**DEPARTMENT OF TRANSPORTATION**

Errata #2

**SUBJECT:** Errata

**DATE:** September 16, 1996

REVISED STANDARD PLAN RSP A24A

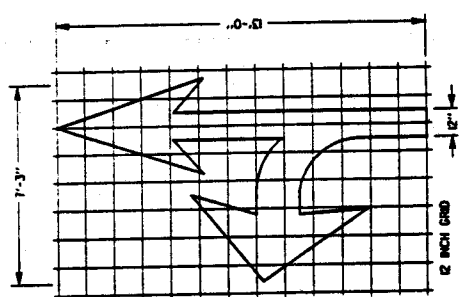
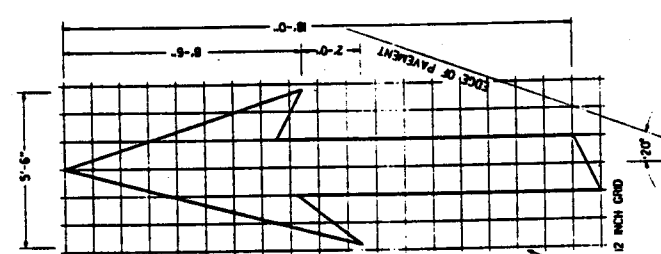
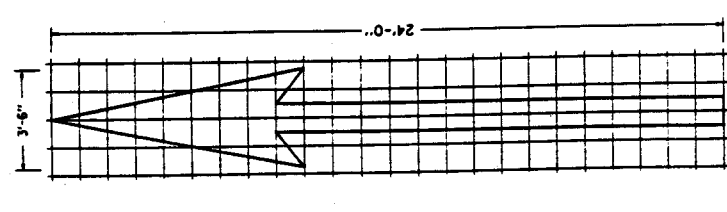
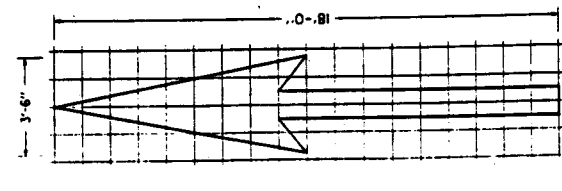
RSP A24A, " Pavement Markings-Arrows", revises the configuration of the Type VI Arrow (Right Lane Drop Arrow) and includes a new details for the Bike Lane Arrow.

REVISED STANDARD PLAN RSP A24C

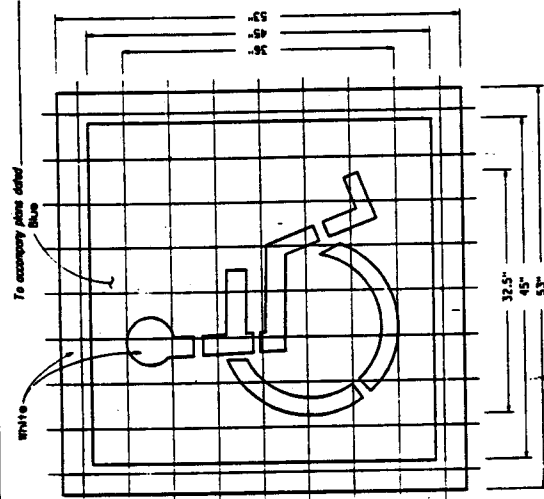
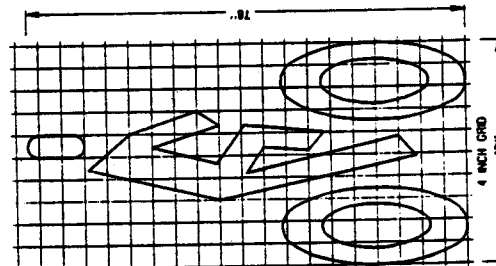
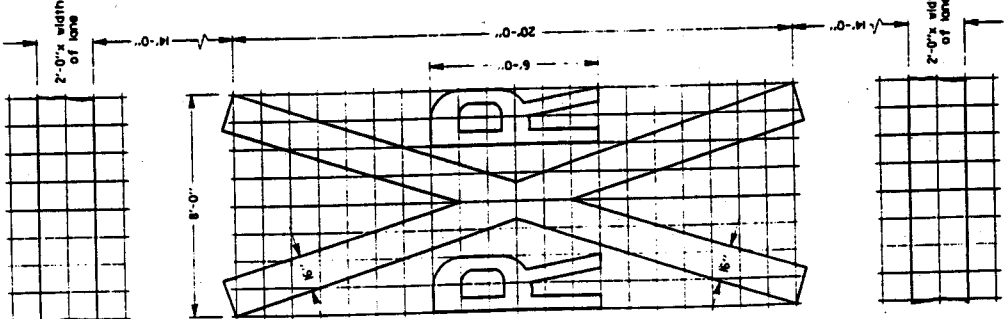
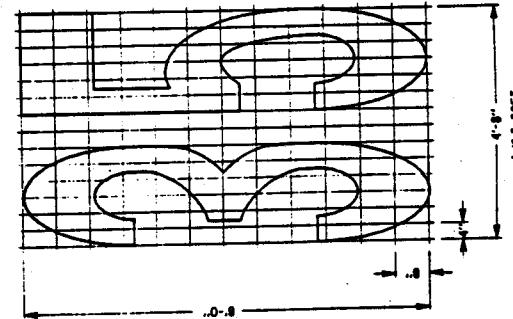
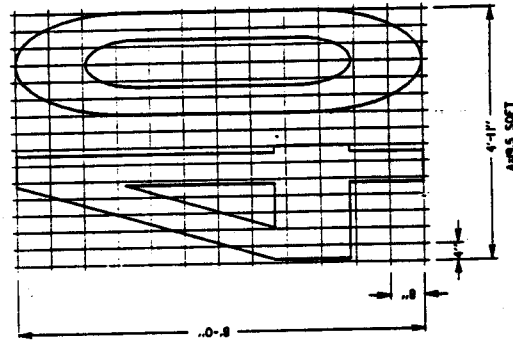
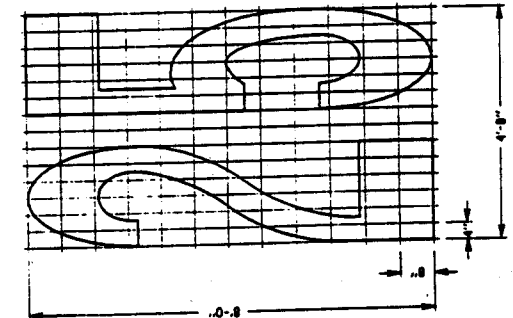
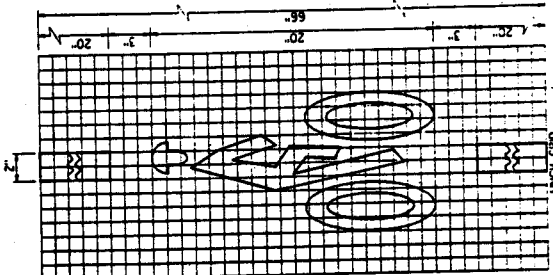
RSP A24C, " Pavement Markings-Symbols and Numerals", revises the details for the Bike Lane Symbol and the Handicapped Parking Symbol and includes a new detail for the Bike Loop Detector Symbol.

**CONCRETE BARRIER TYPE 50E**  
NO SCALE

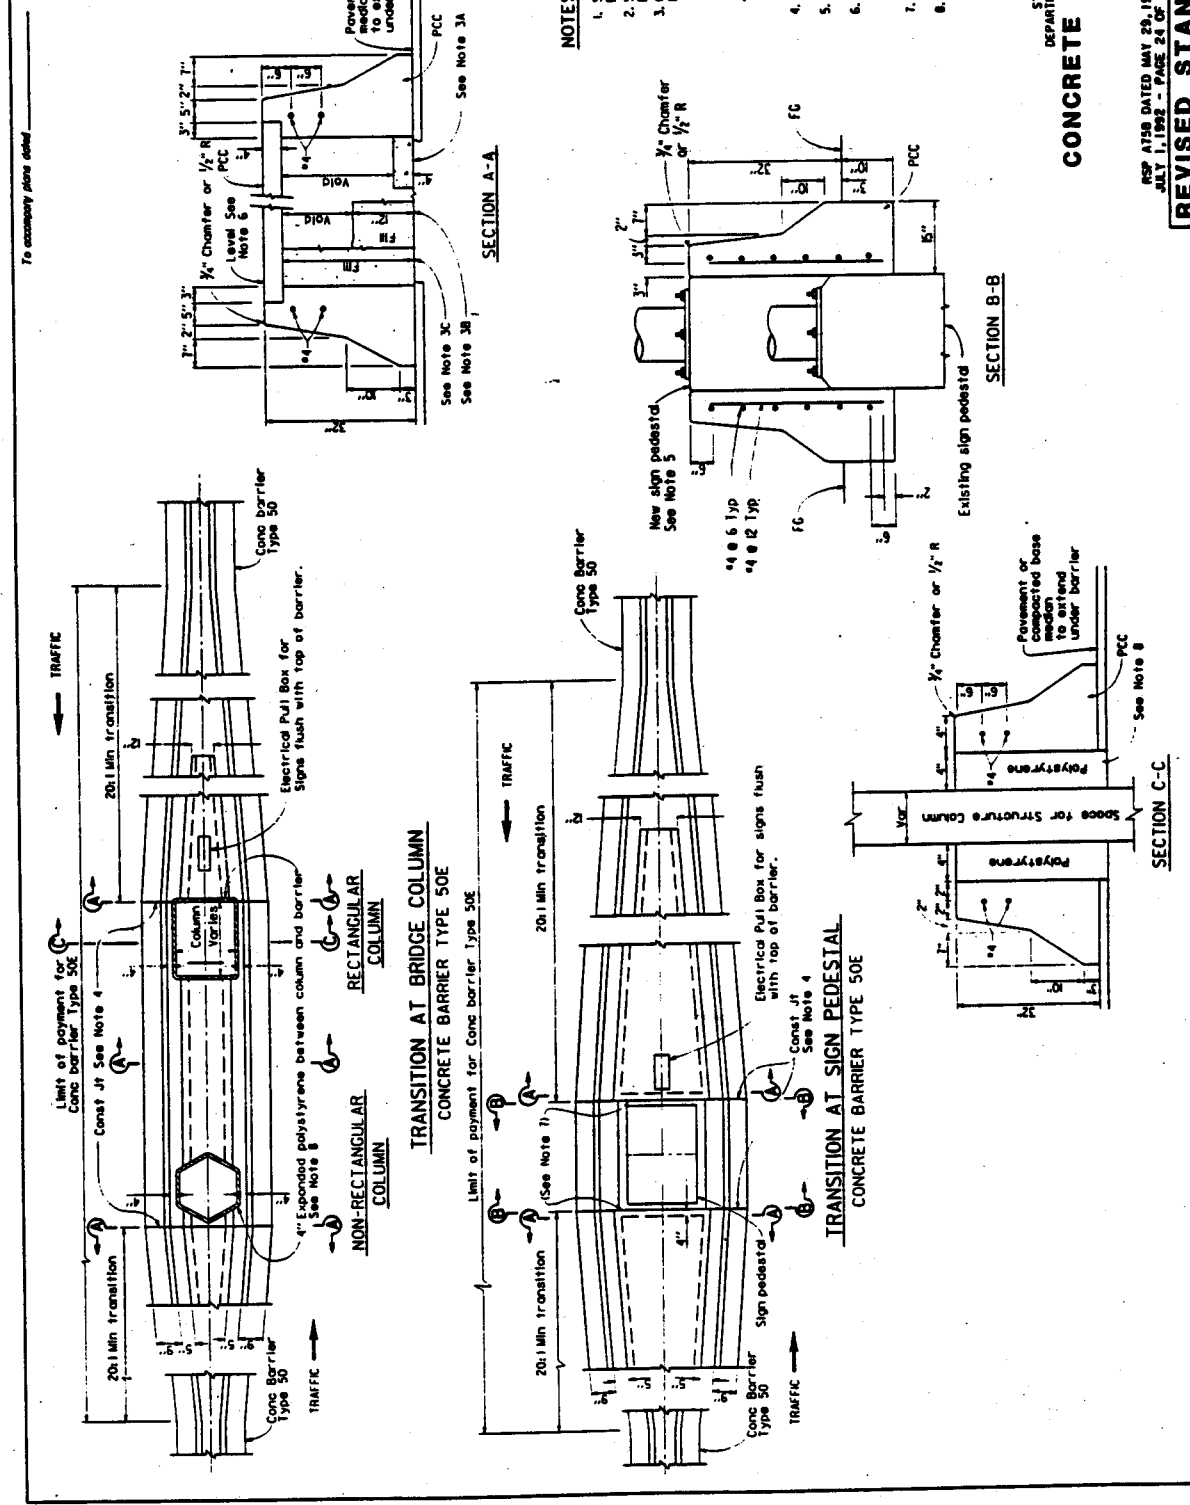
RSP A75B, " Concrete Barrier Type 50E", is revised to increase the thickness of the expanded polystyrene which encloses the columns to 4 inches.

STATE OF CALIFORNIA  
DEPARTMENT OF TRANSPORTATION  
**GUARD RAIL FLARES**  
NO SCALE

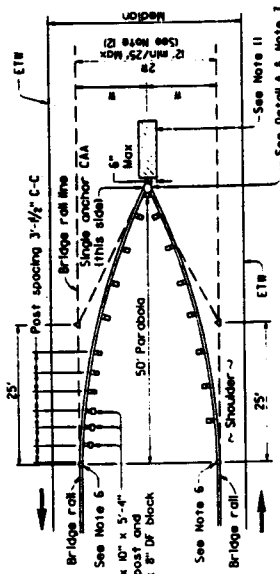
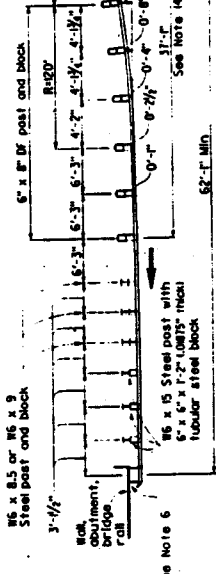
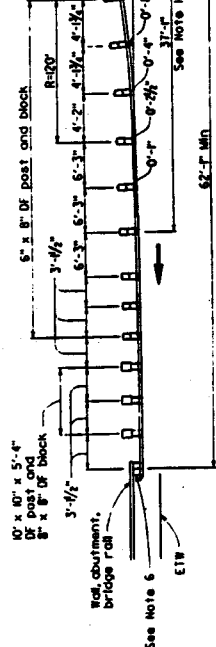
RSP A77D, RSP A77E, RSP A77F, RSP A77G, RSP A78C and New Standard Plan NSP A77GA, provide for the use of new Type M breakaway end anchors for new Type 1M and Type 8M flares used with metal beam guard railing. Type M breakaway anchor assemblies replace Type A breakaway cable anchor assemblies. Type 1M and Type 8M flares replace Type 1 and Type 8 flares, respectively. In addition to the revisions on RSP A77D for the use of Type M breakaway anchor assemblies, the Type 2 flare has been deleted.
